COUNTY ADMINISTRATOR'S OFFICE

October 18, 2018

Re: Response to Hudbay Regarding Intermittency and Surface Water Impacts

Figure 1. Location of the two stage sensors in Barrel Canyon in relationship to alluvial deposits (green) and bedrock (red)⁴. Intermittent flow reach of Barrel Canyon⁵ is noted in blue.

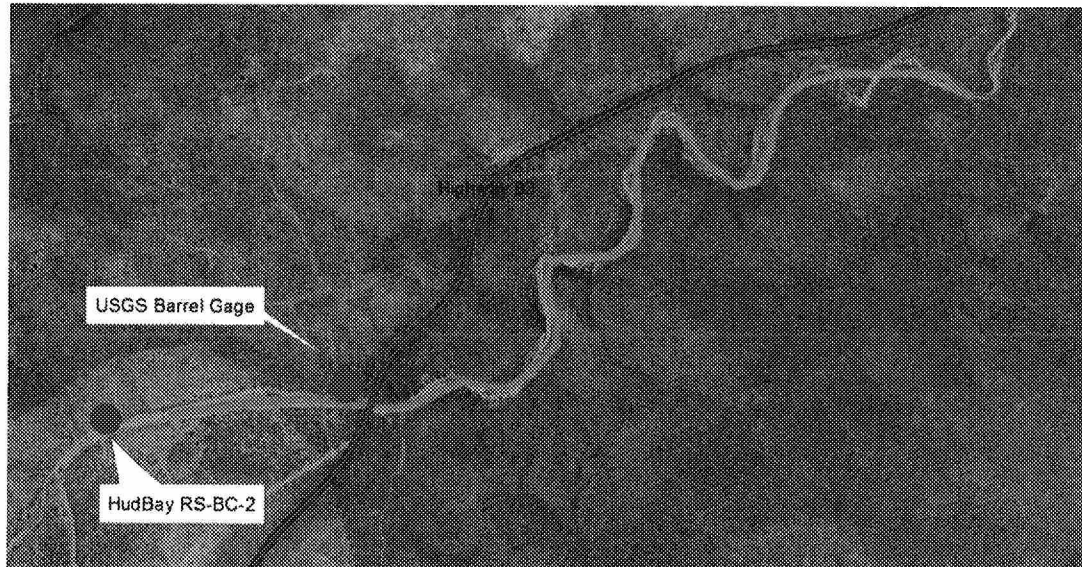
What is particularly relevant to this topic is that Hudbay's flow (stage) sensor in Barrel Canyon (RS-BC-2) is actually located in alluvial deposits and further upstream of the Barrel Spring and USGS gages that demonstrate intermittent flow. Hudbay fails to mention this fact.

Despite this, it should be noted that by the company's own data in the January 25, 2018 letter, anything that is "Bank Storage" is flow, by definition, characteristic of intermittent or perennial streams because it is not associated with storm events.

Figure 2. Days of flow recorded at the USGS 09484580 Barrel Canyon gage at various times since 2015. Data are "Approved for Publication".

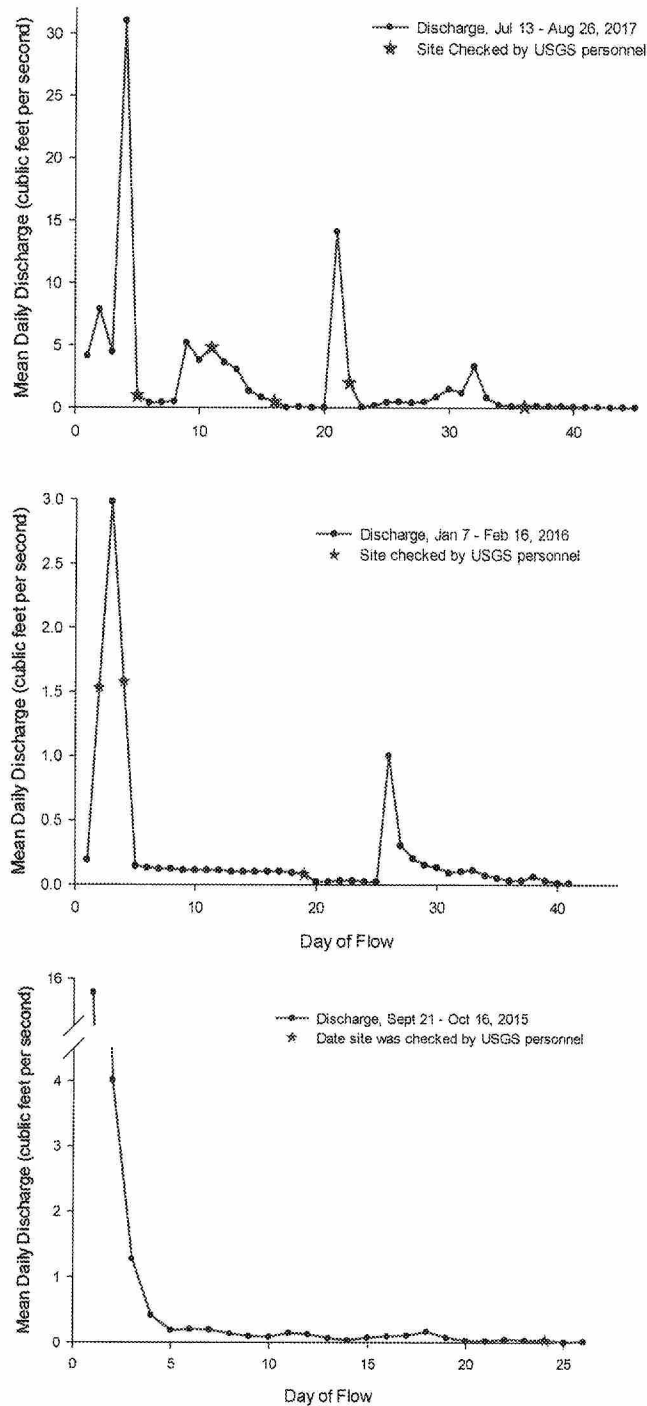
The USGS gage also provides important information showing intermittent flow on the Barrel Canyon. Figure 2 shows flow during three distinct periods of continuous flow since 2015 and Figure 3 shows Barrel Canyon on August 16, 2017, just downstream of the Highway 83 bridge.

Figure 3. Evaporative Demand Drought Index⁸ graph showing the drought conditions (in red). Collection year for the stonefly is noted, but because of the biology of the species, its presence at the site in early 2010 is especially important because of the extremely dry conditions in 2009.

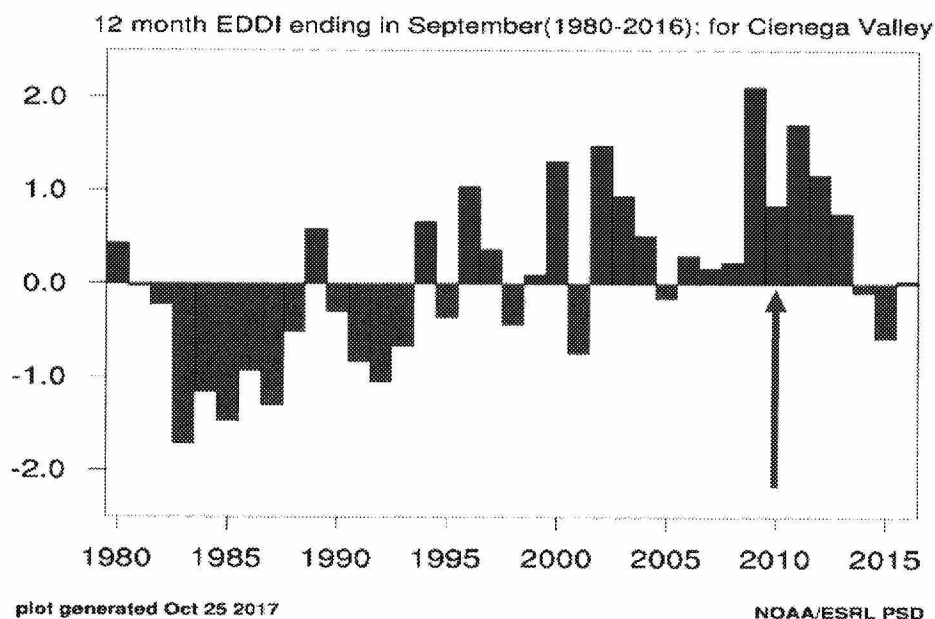
In April 2010, multiple specimens were collected in Barrel Canyon approximately 1500 feet downstream from the Highway 83 bridge and USGS gage⁷, near "Barrel Spring" where shallow bedrock likely enhances the expression of surface flow. The collection occurred just after an extremely dry three-year period (Figure 3), but heavy rains elevated groundwater levels and Barrel Canyon began flowing on January 22, 2010.

Table 2 – Fraction of the Observed Flows Contributing to Davidson

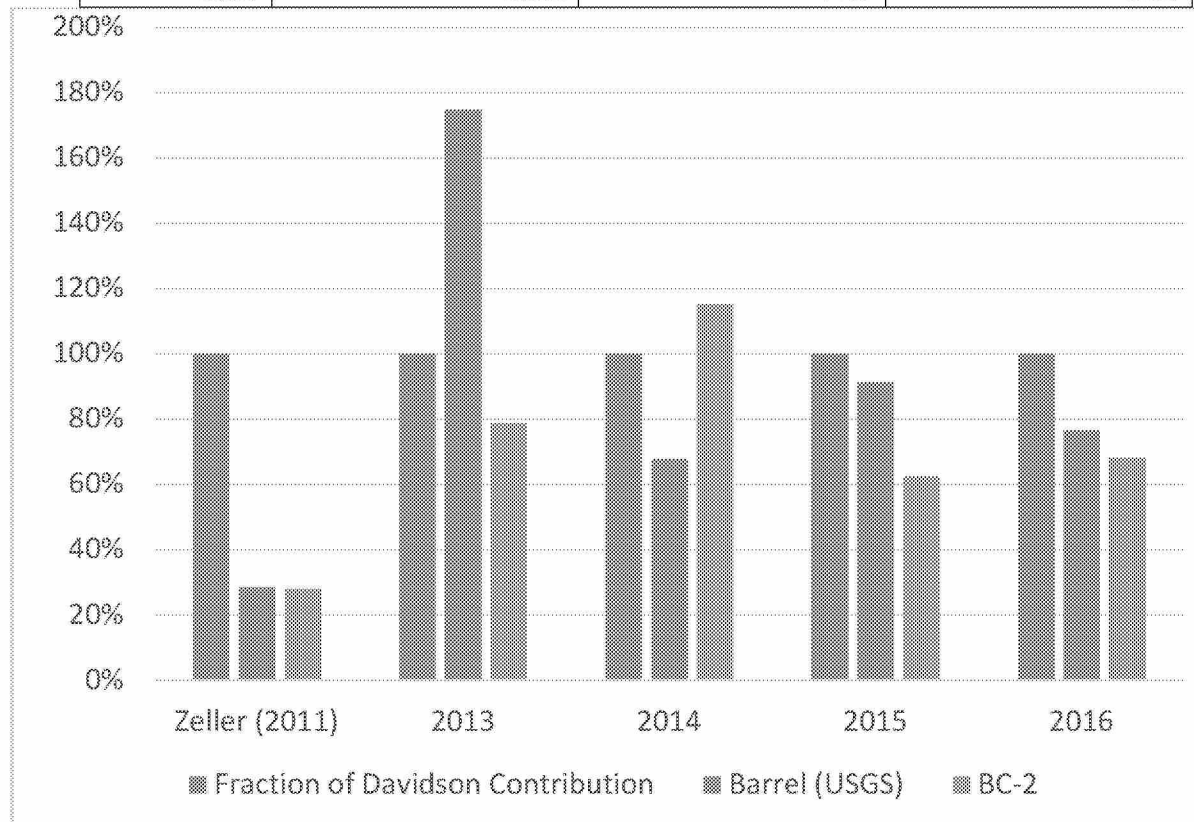
In fact, comparing the observed measurements for the period from 2013 to 2016 (based on data in Table 1), the fraction contributing from Barrel is always more than half of the observed flow at Davidson (Table 2 and Figure 1).

However, their consultant's datasets attached to the transmittal letter confirm that flows from the mine site to Davidson Canyon are significantly higher than predicted by the Zeller method, and the estimate of 4.3% reduction in flows to Davidson indicated in SWCA 2012. Outflows predicted by the Zeller method cannot be considered "conservative" based on the observed data. Barrel watershed's observed outflows during 2013-2016 provided more than half of the observed flows to Davidson.
